Origination Form
Proposed Revisions to a Standard Plans Index

Originator:	Meyer, Ronald and Lemus, Vivian	Index Number:	700-120
Date:	6/22/2026	Sheet Number(s):	1,2,5,6,7
E-mail:	Ronald.Meyer@dot.state.fl.us	Index Title:	ENHANCED HIGHWAY SIGNING ASSEMBLIES

LAST REVISION		DESCRIPTION:		INDEX	
11/01/26	REVISION			700-120	6 of 12

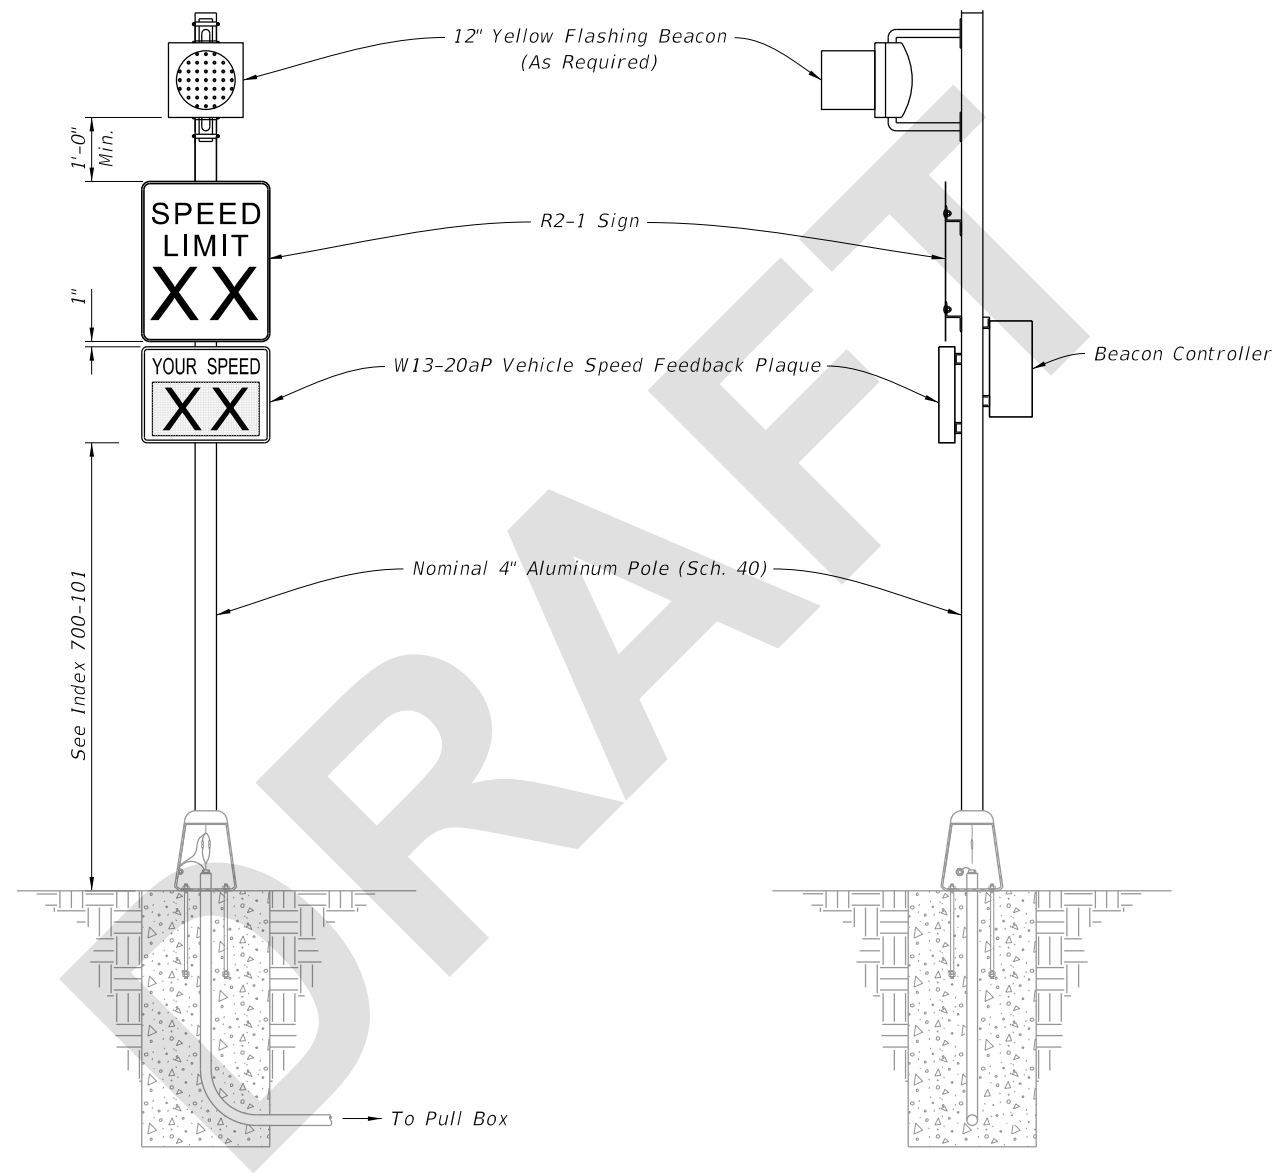
Sheet 7 (New Sheet 6): Added "(As Required)" to the 12" Yellow Flashing Beacon callout; Deleted dimensions for R2-1; Updated the "Electronic Speed Feedback Sign" to "W13-20aP Vehicle Speed Feedback Plaque; Updated the "Your Speed" sign to match the shape and size of the W13-20aP Vehicle Speed Feedback plaque as required and shown in the latest MUTCD; Changed Note 2 - "Install the Vehicle Speed Feedback Plaque in accordance with Specification 700 and 995".

1. Type A6 Assembly (conventionally powered) is shown.
Type B6 Assemblies (solar powered) similar.
2. Install the Vehicle Speed Feedback Plaque in accordance with Specifications 700 and 995.
3. Foundation reinforcement not shown.
